Service Information

Model : Finisher-D1 Ref. No. : FF-T01-W-000087-01

Date: October 8, 1999

Subject PERMANENT COUNTERMEASURE FOR POOR ALIGNMENT DURING SORTING WITH

<Factory measure>

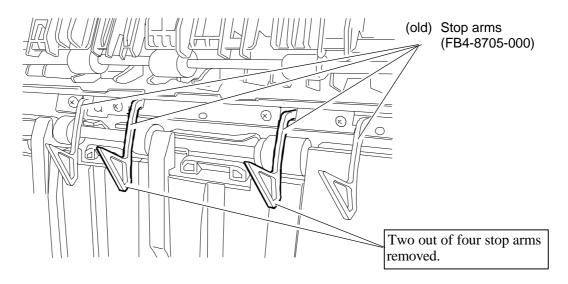
Reason As a permanent countermeasure for poor alignment during sorting with Finisher D1, the shape of the

stop arm has been modified.

Due to the weight of the stop arm in the sort guide, a lower curl tends to develop when the paper is being ejected. In that case, if the paper being used has absorbed moisture, the curl will be all the more pronounced, leading to alignment failure during staple sorting.

As a temporary countermeasure, two out of the four stop arms were removed (see Service Information FF-T01-W-000055-01), and the modification of the shape of the stop arm is being implemented as a permanent countermeasure.

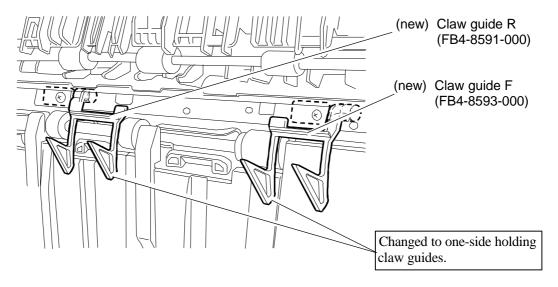
<Temporary countermeasure>

<Permanent countermeasure>

The modifications mean that the stop arm and claw guide (F/R) will no longer be interchangeable, so that all parts will need to be replaced together, or as a unit. However, so that the stop arm can be replaced as a single part, in the event of failure of that part, the old parts and part number will be retained.
